MIL "ON" DTC P2610

Service Category Engine/Hybrid System

YEAR(S)	MODEL(S)	ADDITIONAL INFORMATION
2015 - 2016	ES350

Figure 1. Location of Authorized Modifications Label for 2015 – 2016 ES 350

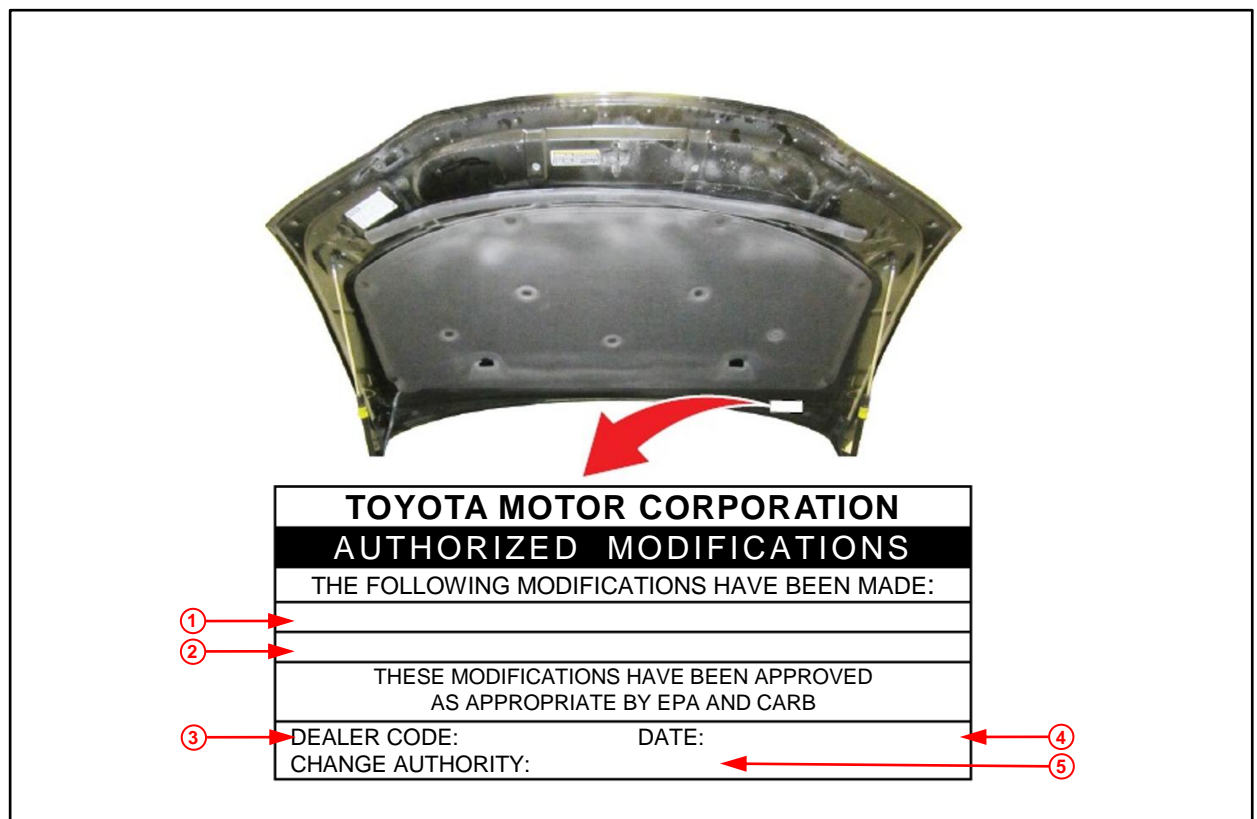
2. Check for the Authorized Modifications Label affixed to the vehicle in the location shown below. Confirm if the ECM (PCM) calibration has been updated.

Is the calibration ID listed the latest ECM (PCM) calibration?

4. Prepare and install the Authorized Modifications Label.
 - A. Using a permanent marker, enter the following information on the label:
 - ECM part number [Refer to the **Parts Information** section for the **NEW PART NUMBER**]
 - Calibration ID(s) [Refer to the **Calibration Information** section for the **NEW CALIBRATION**]
 - Dealer Code
 - Repair Date
 - Change Authority [**This bulletin number**]
 - B. Install the Authorized Modifications Label to the vehicle at the location shown in Figure 1. The Authorized Modifications Label is available through the MDC, P/N 00451-00001-LBL.
5. Test drive the vehicle to confirm proper vehicle operation.
